SUBJECT: LOW-LOW REACTOR WATER LEVEL INSTRUMENTATION MODIFICATION

Re: Oyster Creek Nuclear Generating Station

Amendment No. 91  
License No. DPR-16

SAFETY EVALUATION BY THE OFFICE OF NUCLEAR REACTOR REGULATION  
SUPPORTING AMENDMENT NO. 91 TO PROVISIONAL OPERATING LICENSE NO. DPR-16

GPU NUCLEAR CORPORATION OYSTER CREEK NUCLEAR GENERATING STATION UPDATED FINAL SAFETY ANALYSIS REPORT	REACTOR WATER LEVEL INSTRUMENTATION	
	REV. 0, 12/84	FIGURE 7.6-3

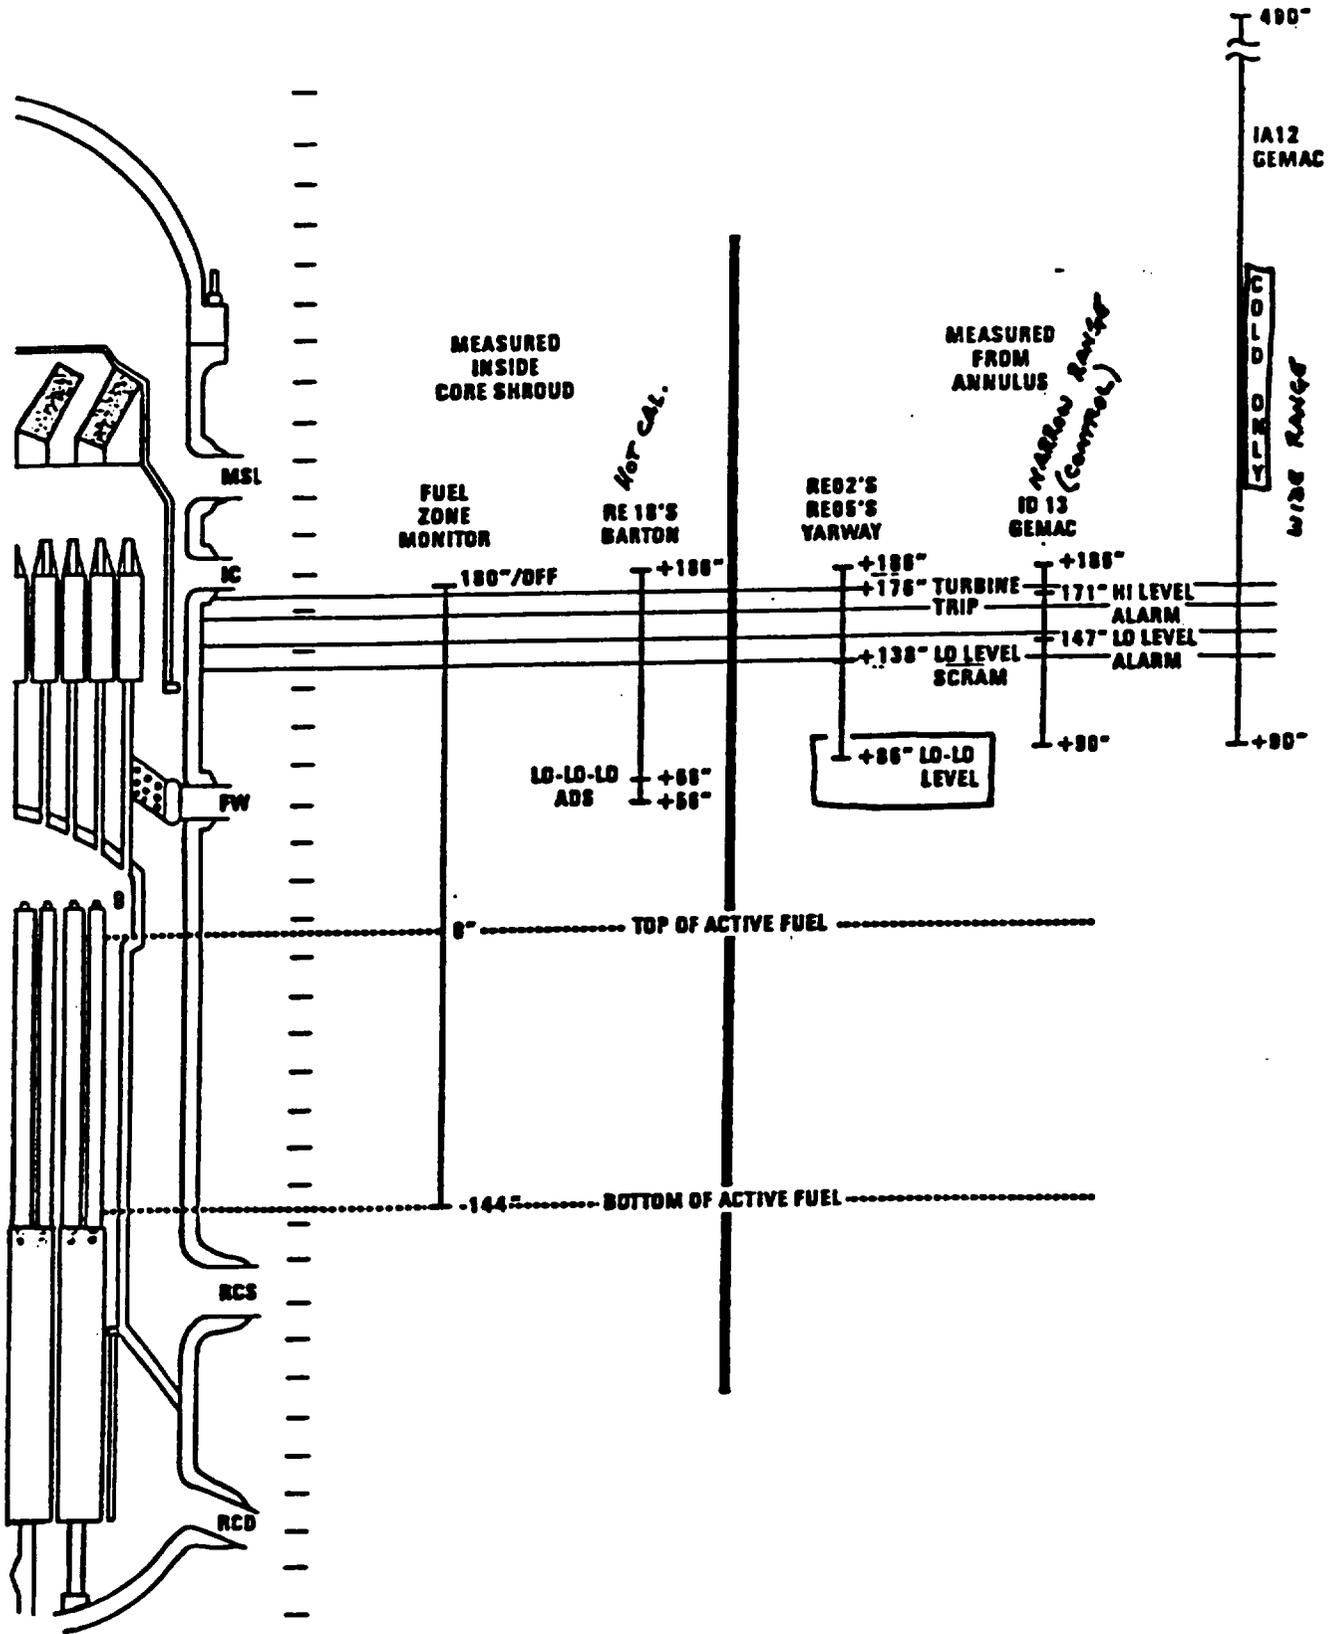
The water level instrumentation system at Oyster Creek consists of five types of level channels, each of which includes redundant channels as shown in the following figure.

The first type is the "fuel zone" set of monitors which cover the range of +180 inches to -144 inches (where "zero" for all channels is the top of the active fuel). This type channel provides indication in the control room but does not provide any automatic actions. The second type is the RE-18 set of Barton instruments which cover the range of +185 inches to +55 inches (above the top of the active fuel). This type has no indication in the control room but provides automatic safety actions at the "low-low-low" setpoint (+55 inches). The third type includes the RE-02 set of Yarway instruments which cover the range of +185 inches to +86 inches (above the top of the active fuel). This type has local indication and provides automatic safety actions at the "low-low" setpoint (+86 inches). This type also includes the RE-05/19 set of Yarway instruments which covers the same range, has control room and local indication, and provides automatic safety actions at the "hi" level setpoint (+176 inches) and at the "low" level setpoint (+138 inches). The fourth type is the ID-13 narrow range GE/MAC instruments which are "hot calibrated" to cover the range of +185 inches to +90 inches (above the top of the active fuel). This type has control room indication, has automatic control function, and is used primarily during normal power operation. This type also includes an alarm at a high level value of +176 inches and at a low level value of +147 inches, where the nominal operating level is +165 inches. The fifth type is the ID-12 wide range GE/MAC instruments which are "cold calibrated" to cover the range of +490 inches to +90 inches (above the top of the active fuel).

The licensee's planned equipment changes are to be conducted with the plant in cold shutdown and include replacing the transmitters and rerouting of the hydraulic sensing lines within the instrument racks for all the channels in the first and third types presented above. The issues of safety concern include the adequacy of the control room indication of the remaining channels and the automatic safety actions that would have been provided by the channels that will be out of service during the replacements.

The nature of the modifications is such that the root valves for each set of sensing lines will have to be closed. In our review, the staff raised questions regarding the feasibility of isolating only one side of the reactor vessel level instruments at a time (i.e., channels A and B, and then channels C and D). This approach would have the benefit of leaving one side operable and capable of providing indication and automatic safety action throughout the modification process. The licensee stated that to replace all of the sets of instruments simultaneously has been estimated to require 24 days and that to replace only one side at a time would require an additional outage time of at least 20 days. The licensee has stated further that this aspect of the outage is the critical path item and that the work time estimates have been carefully scrutinized and are believed to be realistic. Accordingly, if the TS change is approved, the licensee plans to replace all the affected instruments simultaneously on a two, 10-hour shift basis.

To address this concern the staff questioned the licensee regarding the remaining operable water level instruments, installed alarm features, and water injection systems. Two types of instruments that have indications in the control room will be operable. These are the fourth and fifth types described earlier, the narrow range and wide range GE/MAC channels. Either narrow range channel can be selected to provide the water level input to the flow/level recorder, which provides an alarm if the water level falls to +146 inches. By written instruction, the "A" channel has been selected. The "B" narrow range channel has been temporarily fitted with a separate alarm, also

The staff raised a question regarding the accuracy of the "hot-calibrated" narrow range GE/MAC channels when being operated under cold conditions. The licensee responded that engineering calculations indicate that during cold operations the hot-calibrated narrow range instruments would be in error by only 0.6 of 1 inch. In discussing this question with people experienced at other BWRs, the staff got reports that the error to be expected may be 6 to 10 inches and that the Yarway instruments could deviate from the hot-calibrated GE/MAC instruments by as much as 27 to 40 inches. In subsequent discussions, the licensee indicated that, with the plant at hot full power conditions, the cold-calibrated wide range GE/MAC channels currently indicated 126 inches while the hot-calibrated narrow-range GE/MAC channels indicate 160 inches, a difference of 34 inches. The licensee stated also that its experienced reactor operators report that during cold operations, the hot-calibrated narrow range GE/MAC channels will typically agree with the cold-calibrated wide-range GE/MAC within 10 inches. The narrow range and wide range GE/MAC channels were calibrated by the licensee in the last week before shutdown.

set at +146 inches. Thus redundant alarms are being provided. The licensee has agreed to test these low-level alarms prior to the modification and to direct the reactor operators to initiate manually most of the systems that would have been initiated automatically at "low-low" level if any of the remaining operable level instruments indicate at or below the low level setpoint value. This action was implemented by a special written directive to the reactor operators and is included in the licensee's letter of October 22, 1985. This manual initiation includes:

The licensee has agreed to take data and plot the responses of the level instruments during the plant cooldown to verify the indications corresponding to the actual values of +138 and +86 inches, the "low" and "low-low" setpoints. The operator will be alerted by the alarm at +146 inches and will act if any of the GE/MAC channels (narrow or wide range) reach the value corresponding to the "low" setpoint. The span of 52 inches between the "low" and "low-low" setpoints is adequate to accommodate errors in instrument indications between "hot" and "cold" conditions. Therefore, this question is resolved to an acceptable degree.
